August 29, 2003

Refer to: HSA-10/B-109A

Mr. Daniel J. Mushett
Interstate Timber Products Co.
111 Garnet Lane
Oak Ridge, Tennessee 37830

TITLE		PC-BLOCK	
DATE		DATE	
DRAWN BY		SCALE	
CHECKED BY		FULL	
ADVANTAGE MOLD 525 N. Woodling Street - Toledo OH, 43606 TEL: 419-488-3303 FAX: 419-488-3314 WWW.BURKETT HOLDING.COM

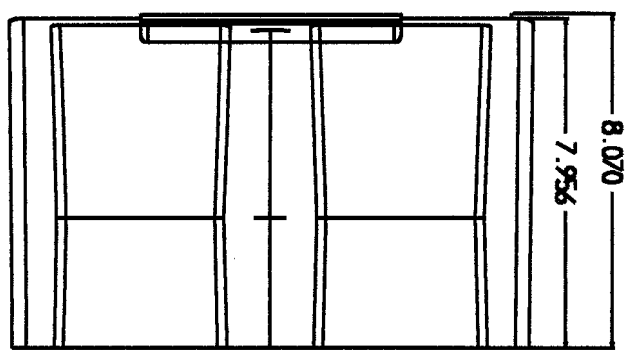
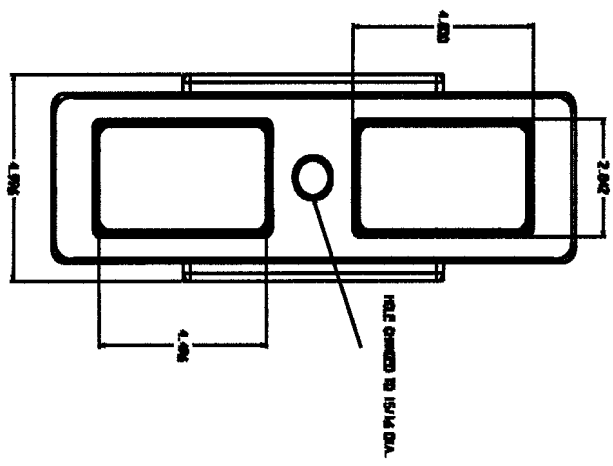
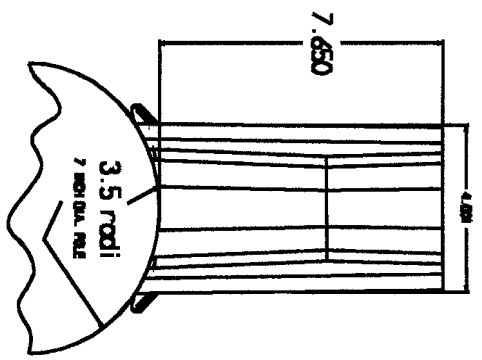
In your July 11, 2003, letter to Mr. Richard Powers of my staff you requested acceptance of a similar offset block for use with round wood posts, an alternative strong post w-beam guardrail system used by some State Departments of Transportation. You indicated that the modified block (PC-Block) is comprised of the same materials as the P-Block (50/48 blend of High Density Polyethylene (HDPE) and Low Density Polyethylene (LDPE) with 2 per cent blowing agent), but has modified dimensions to fit the round wood post. Specifically, the traffic face remains 4-inches wide and its effective depth has been retained at 7.65 inches, but the field side of the block has an approximate 3.5-inch radius to fit against the standard 7-inch diameter round wood posts. These details are shown on the enclosed drawing.

I agree that this block is acceptable for use with strong, round post w-beam guardrail installations on the NHS. Please note the following standard provisions that apply to FHWA letters of acceptance:
